From: Zheng Hua 郑华(ACPR1000研发项目部) <zhenghua2@cgnpc.com.cn>
Sent: Monday, September 12, 2016 9:09 PM
To: Gallagher, Carol; Kaplan, Michele
Subject: [External_Sender] Dear Sir, is Figure 5 in "Regulatory analysis for the final rule amending 10 CFR Part 171" (ML16054A285) wrong?
Attachments: Figure 5 from ML16054A285 and ZHENG Hua's calculation result.docx

I have read "Regulatory analysis for the final rule amending 10 CFR Part 171" (ML16054A285), and I think Figure 5 in this document is wrong. Please check it.

Figure 5 from ML16054A285

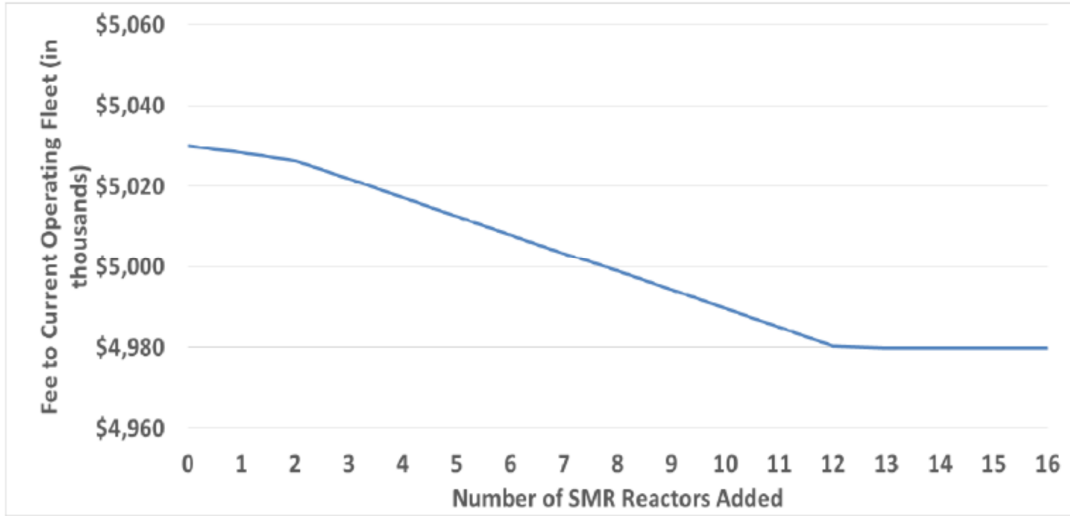
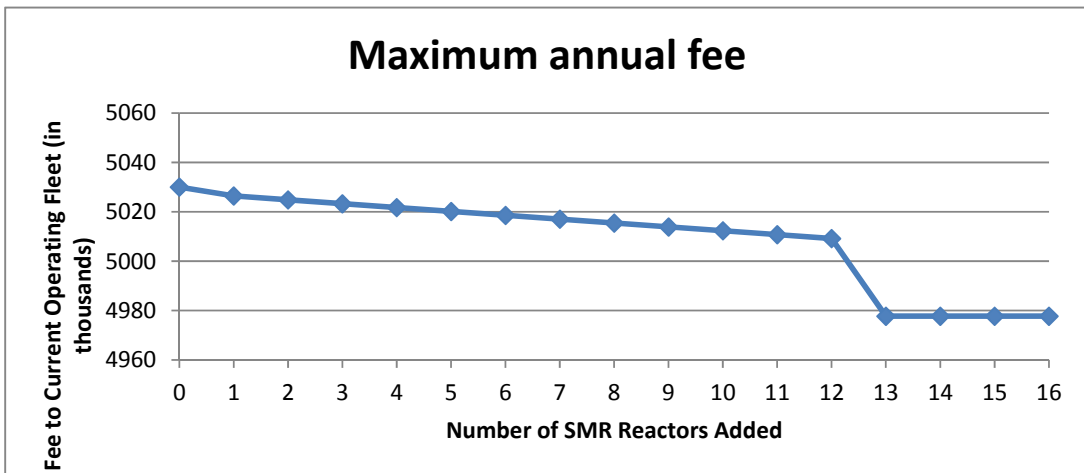
For 12 NuScale modules, the cumulated thermal power is 1920 MWt (160MWt per module), smaller than 2000 MWt, which means for this SMR facility, only minimum annual fee and variable fee is needed; but for 13 NuScale modules, the cumulated thermal power is 2080 MWt, greater than 2000 MWt, which means for this SMR facility, only maximum annual fee is needed and the annual fee for current operating fleet will decrease greatly.

Calculation result of Zheng Hua
